CITY of NOVI CITY COUNCIL

Agenda Item P
June 16, 2014

SUBJECT: Approval of a request from Shastco, LLC for a variance from Chapter 5, Section 2.2.4 (B)(7) of the Engineering Design Manual to allow the construction of a permanent storm water pump station to service a limited amount of drainage in the immediate area of the truck dock/service area of 22285 Roethel Drive, subject to the applicant meeting all requirements of said section of the Engineering Design Manual.

RE: **Truckwell (22285 Roethel Drive), JSP14-26**
City of Novi, Oakland County, Michigan

PROJECT NUMBER
14040
 SHEET NUMBER
C-7

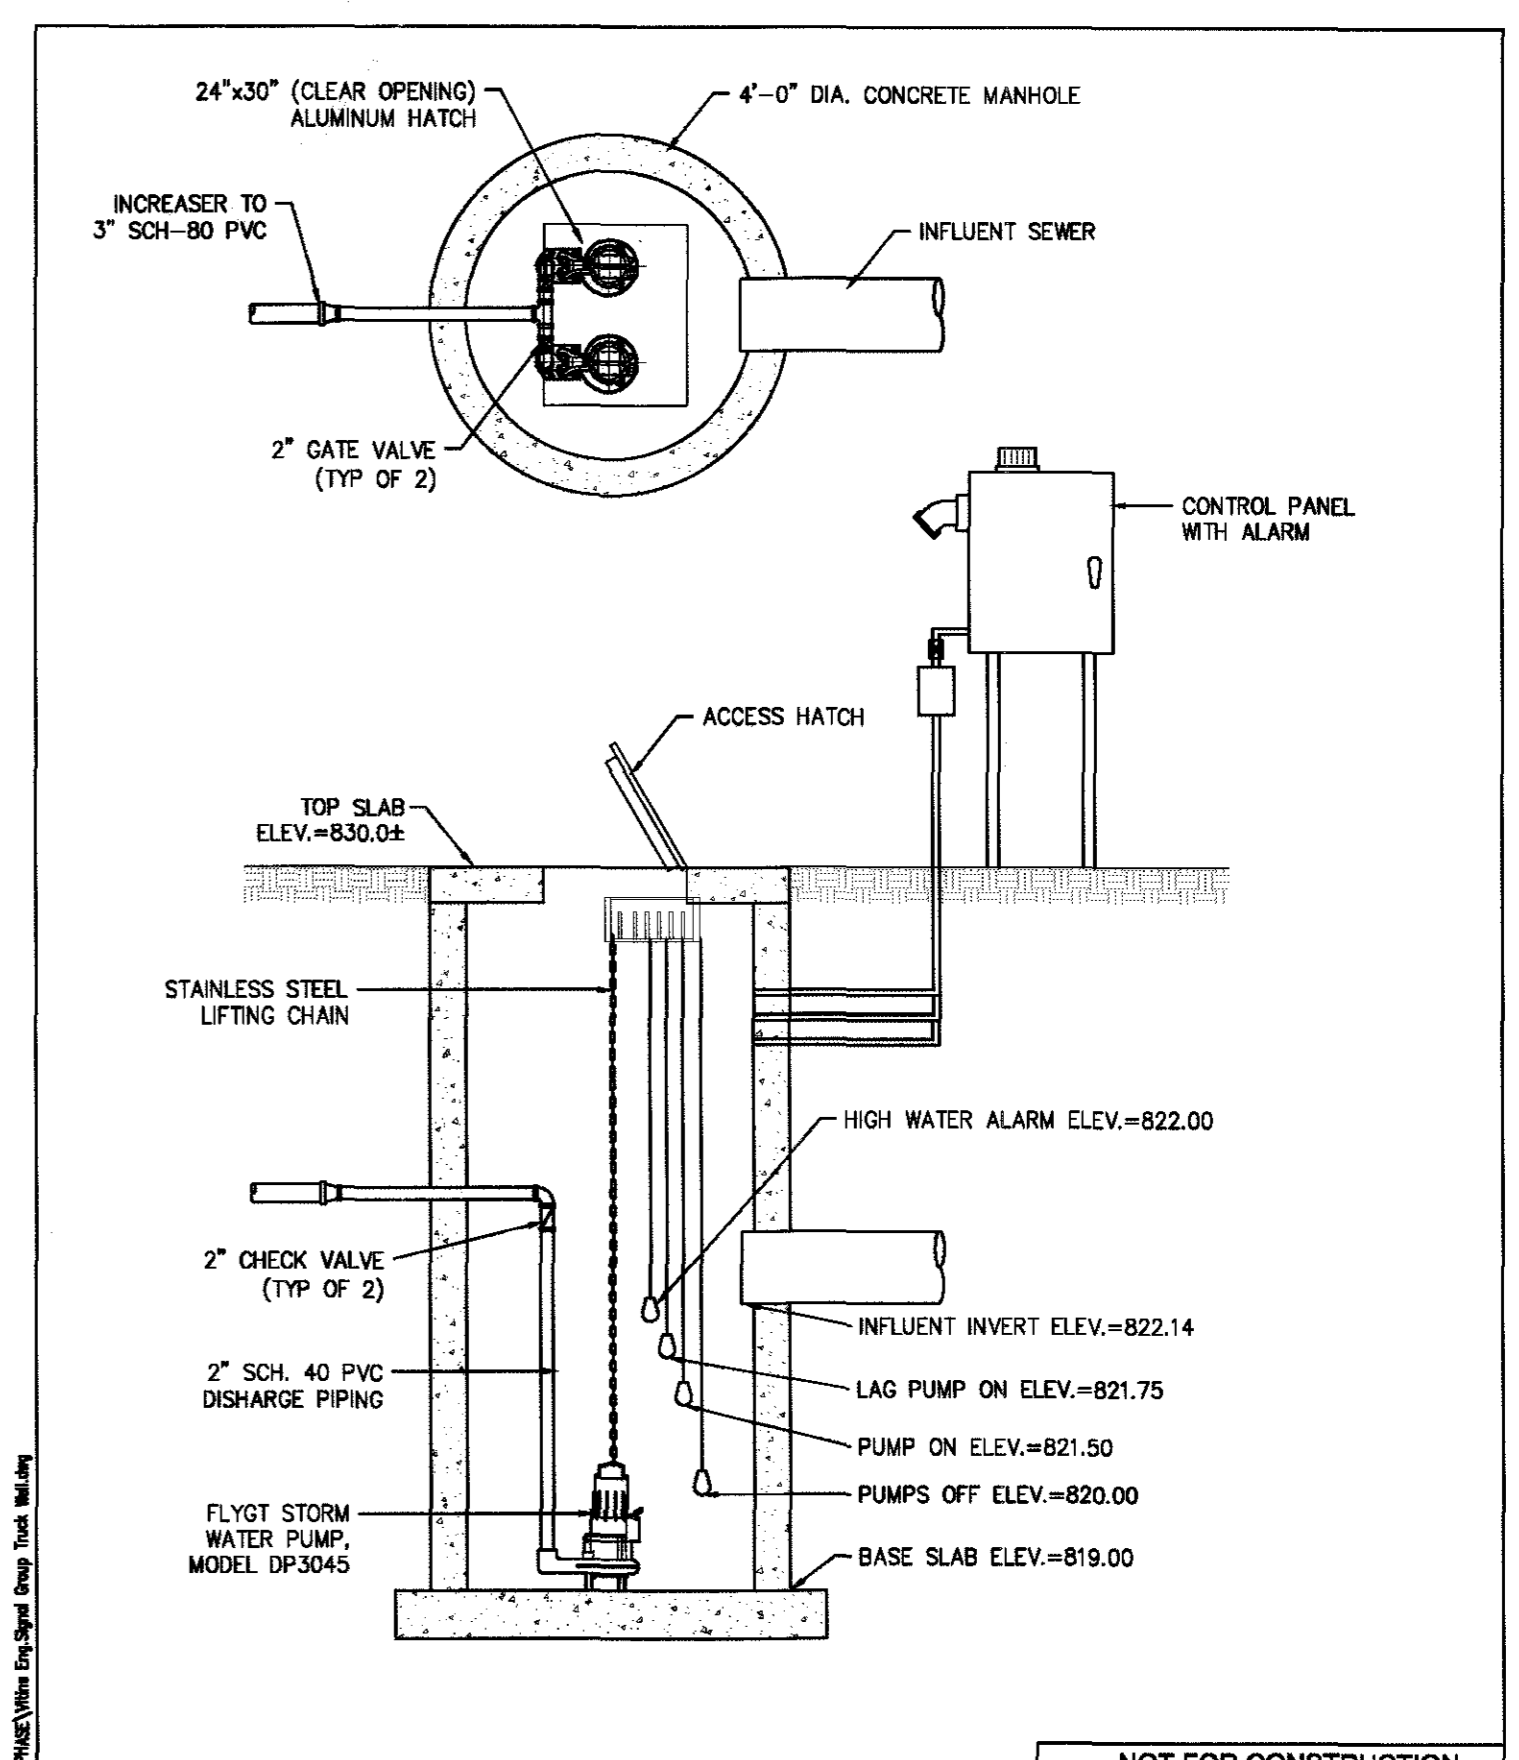
- ✓ 5. Pump station details are included on Sheet C-7.
- ✓ 6. Storm sewer profile is shown on Sheet C-4.
- ✓ 7. Upstream and downstream inverts are provided for Catch Basin 1.

- ✓ 8. Each pump has been sized for the 10 year storm event but the pump is also capable of pumping the 100 year storm event.
 - ✓ A portable generator shall be provided along with a generator receptacle in the control panel.
 - ✓ A high water alarm and pump failure alarm will be provided at the control panel inside the building.

- PUMPS (2) SHALL BE FLYGT SUBMERSIBLE EFFLUENT PUMP MODEL DP3045, 234 IMPELLER, 1.8 HP, 3 PHASE, 230V WITH 2" DISCHARGE, PUMP FEET AND 30" CABLE.
- EACH PUMP RATED 87 GPM AT 12.4 TDH (100 YEAR INTENSITY STORM).

- ALARM SHALL BE PROVIDED FOR HIGH WATER AND PUMP FAILURE.
- PUMP STATION SHALL HAVE LOT MERCURY TYPE FLOAT SWITCHES AND STAINLESS STEEL SUPPORT BRACKET.
